May a 4P AT-PSE power each
2P autonomously?

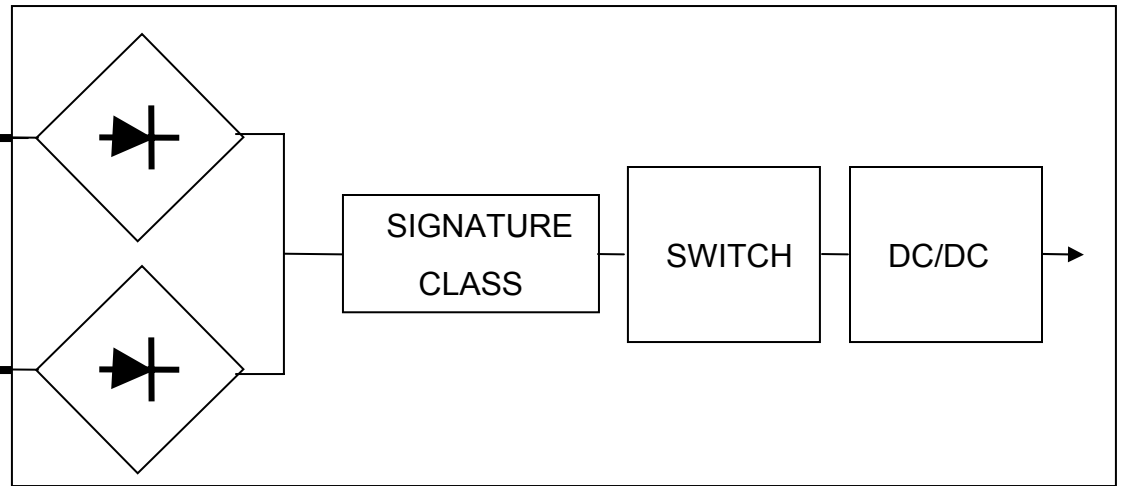
In this situation, the AF-PD would see double inrush current (900mA) which might stress a FET, cap, or fuse. The PD would have 30W available which might allow fire in fault condition.

As a minimum, 4P PSE must check for above condition when an AF-PD is detected and limit power/current to AF levels.

To maintain identical AF operation, I would propose AF-PDs be powered over 2P, as is done today.
